H. B. ROBINSON UNIT NO. 2  
LICENSE DPR-23

ADDITIONAL INFORMATION IN SUPPORT OF 100% THERMAL POWER  
AUTHORIZATION AND TECHNICAL SPECIFICATION MODIFICATIONS

ATTACHMENT I  
ADDITIONAL INFORMATION REQUESTED IN LETTER OF AUGUST 3, 1973  
H. B. ROBINSON UNIT NO. 2  
DOCKET NO. 50-261

FIGURE 1

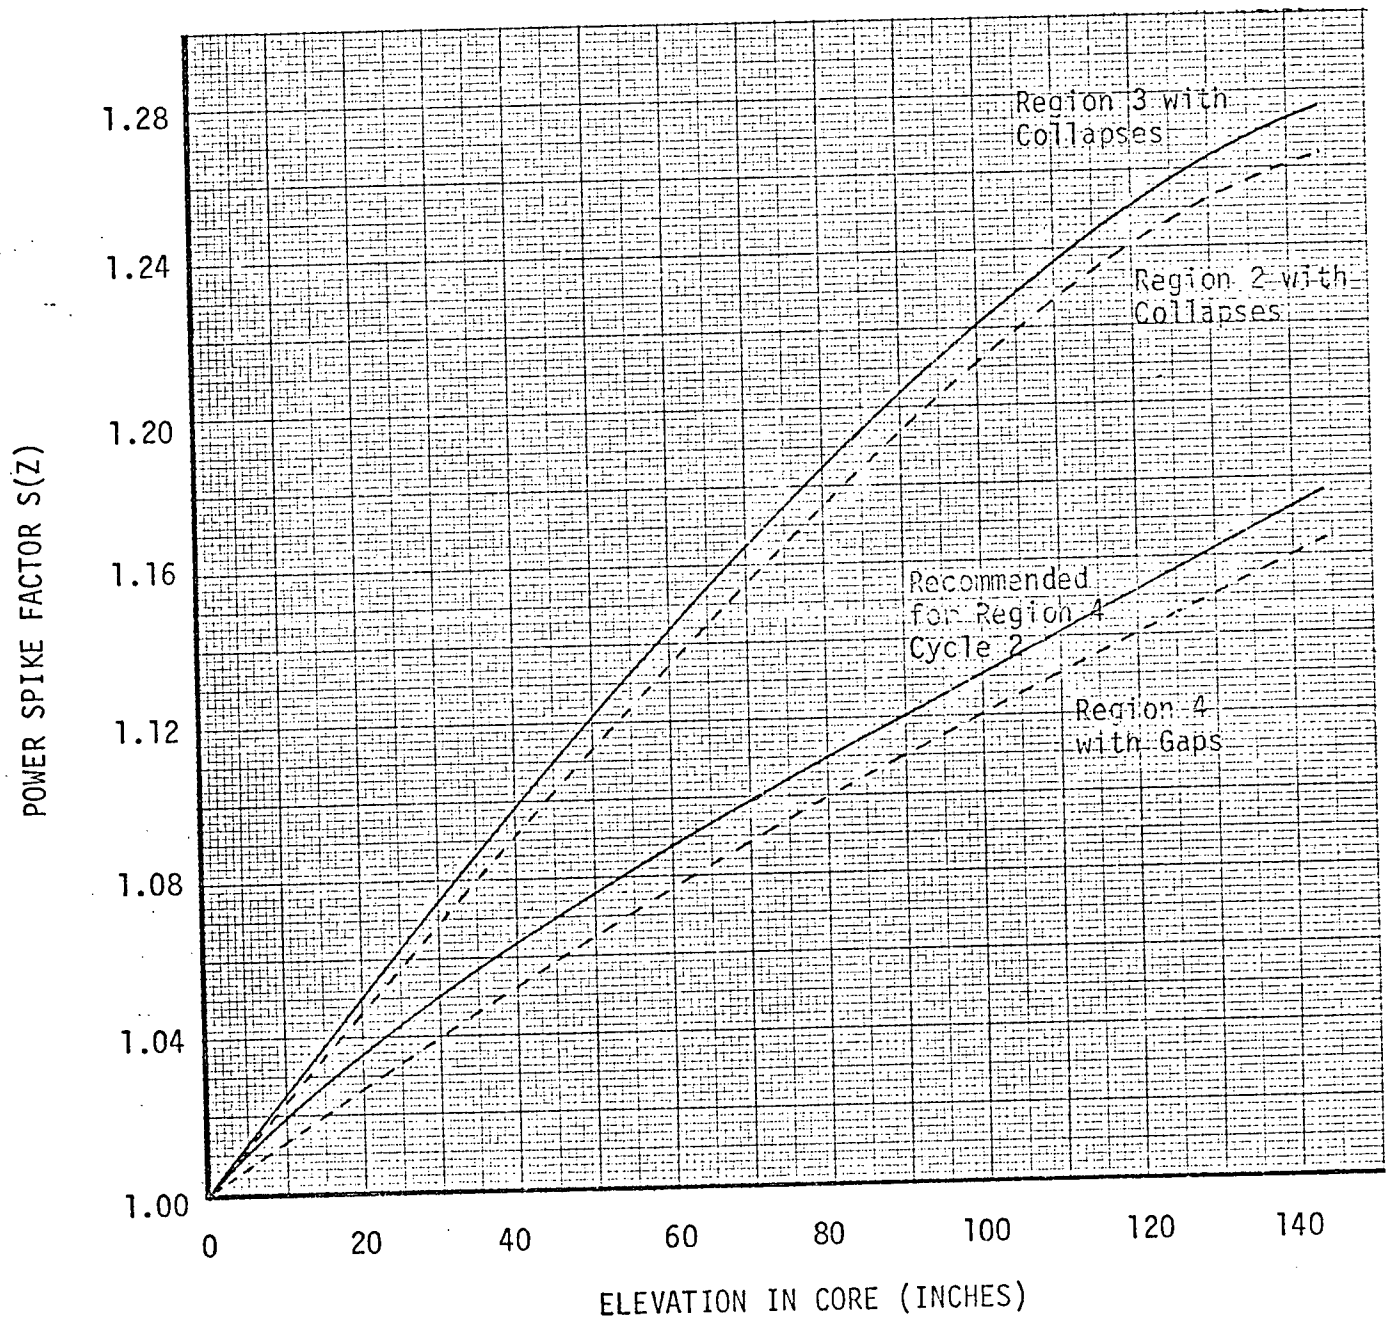
2. A new  $S(Z)$  curve for region 4 has been constructed to allow for possible collapses in neighboring region 2 fuel assemblies. This curve is based on a detailed analysis of assembly-wise power distributions calculated for Carolina Power & Light Company, Cycle 2 by the PHASTR two-dimensional diffusion theory code. Beginning-of-cycle and end-of-cycle rodwise power distribution for region 4 assemblies which border region 2 assemblies (and could possibly contain the hot rod) were studied. The effect of a collapse in an outer row rod of a region 2 fuel assembly on the adjacent region 4 rods was compared to the effect of a gap in a region 4 rod next to the hot rod in the assembly. At beginning-of-cycle the maximum power achievable in the hot rod due to a gap in an adjacent rod is greater ( $\sim 4\%$ ) than the power which can be achieved in an outer rod due to a collapse in an adjacent region 2 assembly. An end-of-cycle, however, the outer rod can be approximately 1% higher in power than the hot rod due to the same phenomena as at BOL due to power flattening with burnup. An increase in the power spike factor,  $S(Z)$ , for region 4 of Cycle 2 is therefore recommended such that the hot rod is adequately predicted. Figure 1 shows the suggested curve.

This recommended curve provides good verification of the 1.15 value suggested by Carolina Power & Light Company for region 4 in memo NG-73-110<sup>(2)</sup>. In Figure 1 it can be seen that the value 1.15 agrees quite well with the 1.25 value for regions 2 and 3 at 120 inches elevation. On this basis, then, the default value of 1.15 for  $S(Z)$  in region 4 need not be increased by a factor of 1.01.
